# **THE NATION MUNICIPALITY**

## **VILLAGE OF LIMOGES LIMOGES SEWAGE LAGOONS**

### **REPORT ON REPAIR WORKS TO LEAKS**

**JANUARY 2003**

DWG. NO.:  
**200025-G**

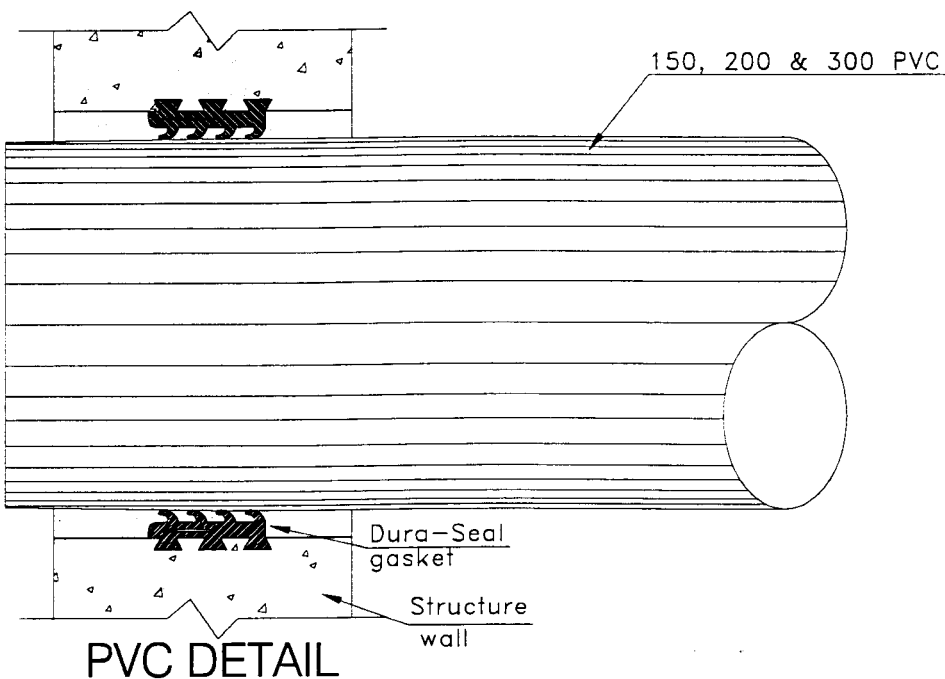
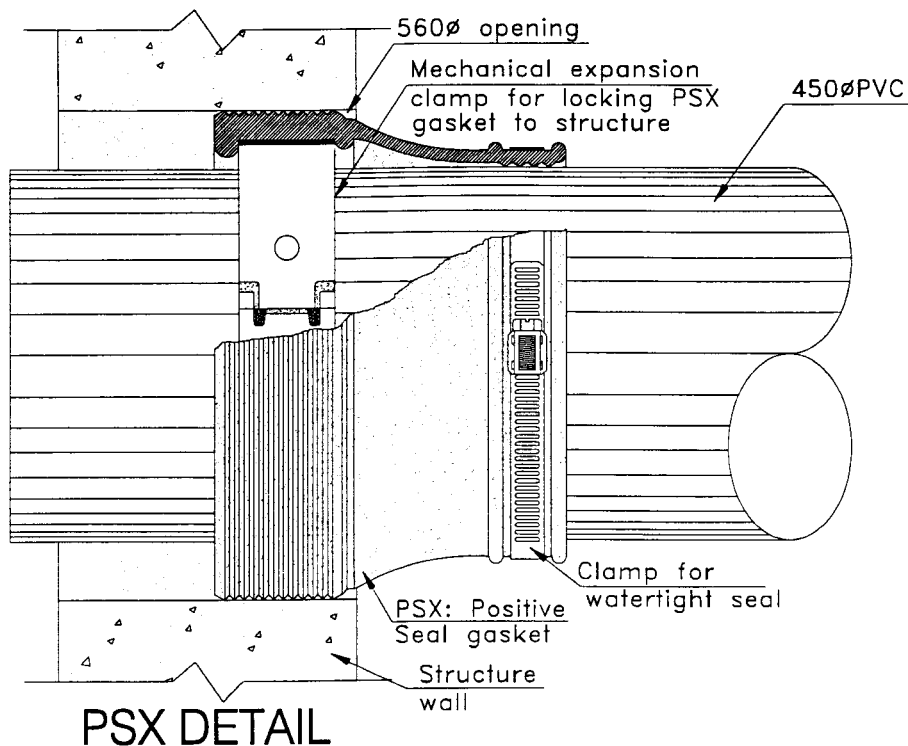
1. No dresser couplings on the outfall discharge piping as indicated on the "As Constructed" drawings

- 6- There is no dresser couplings on the discharge piping as indicated on the "As-Constructed" drawings because a PSX positive seal gasket was used instead. Please refer to the attached shop drawing approved March 17<sup>th</sup>, 2000. We will make the necessary modifications to the as-built plan.
